Delegated Report

Householder Planning Application

Planning Application No: 20240121

Description: Erection of a single storey side extension with the creation of the new front vehicle crossover with engineering operations to alter front land levels and a new front balcony.

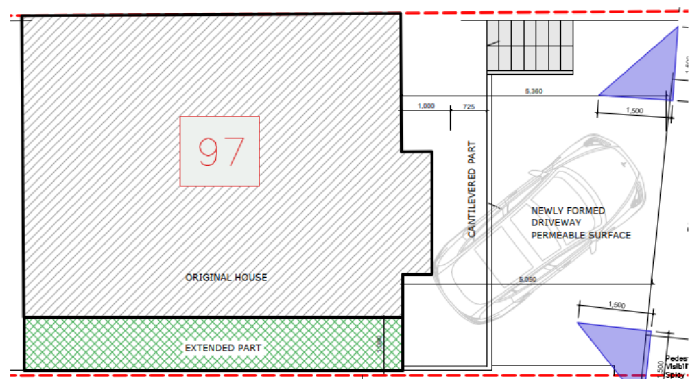
The single storey front extension has been removed from the proposal, with only the single storey side remaining and the proposed parking layout has been amended as can be seen from the following comparisons:

The proposed development also comprises of the erection of a balcony to the front at the ground floor level which would sit above the proposed parking area. This would create a new feature to the streetscene which is relatively uniform and would look at odds within the property setting. As such, it is considered that the front balcony would be an incongruous development that would look at odds with the property, the streetscene as a whole and would not improve the visual amenity of the area

The revised parking layout are deemed acceptable from both the GBC Highways Officer and KCC Highways and Transportation. The parallel parking arrangement would avoid any vehicles overhanging the footpath and whilst not shown on the plans, it would appear that there would be adequate vision splays.
